# Am85C30 Enhanced Serial Communication Controller

*Application/Errata Note*

### Errata 1. Valid Access Recovery Time (Parameter #49) Violation

Figure 1

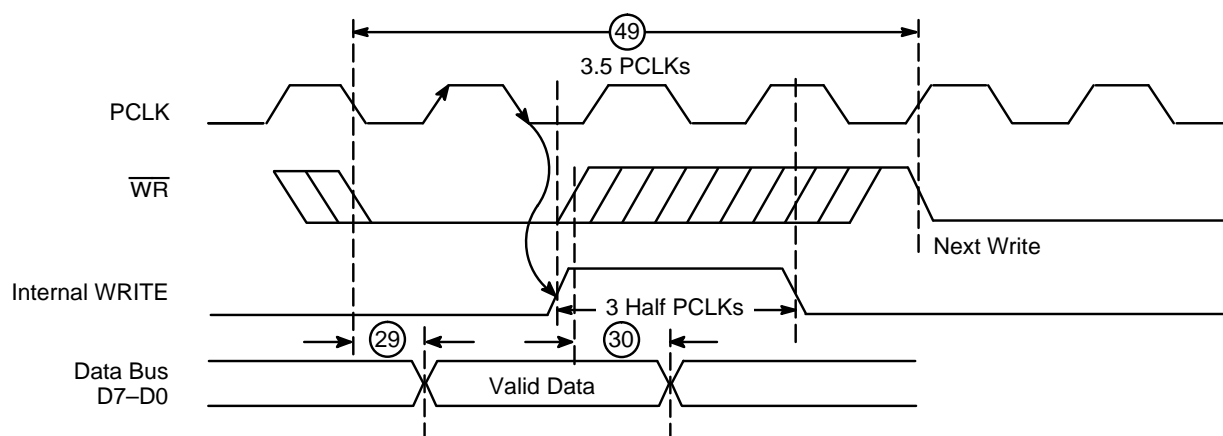
The Am85C30 (ESCC) device may have invalid data written into its registers/FIFO if parameter #49 (Trc; Valid Access Recovery Time) is violated. This means that if the system (CPU) does another write operation, to

ESCC or any other device, during the 3 to 3.5 PCLK time period required by the ESCC to complete its internal WRITE, the ESCC may write incorrect data to its internal registers/FIFO.

**Figure 2**

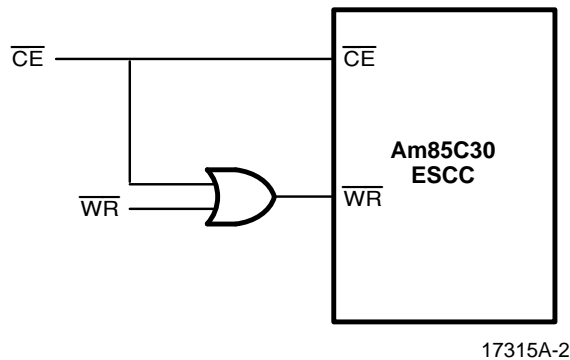
ESCC may have invalid data written into its registers/ FIFO if another WRITE (to ESCC or some other device with the common WR strobe) is attempted during the valid access recovery time (i.e., parameter #49). The ESCC does not qualify the write strobe ( $\overline{WR}$ ) with chip enable ( $\overline{CE}$ ). In most applications PCLK is same or faster than CPU clock and the CPU cannot do another read or write access in the recovery time required by the ESCC, thus the above will not be a problem.

If PCLK is slower than CPU clock, then any extra non-ESCC WRITES during the valid access recovery time can be stopped by gating the external WR with CE of the ESCC (see Figure 2 below).
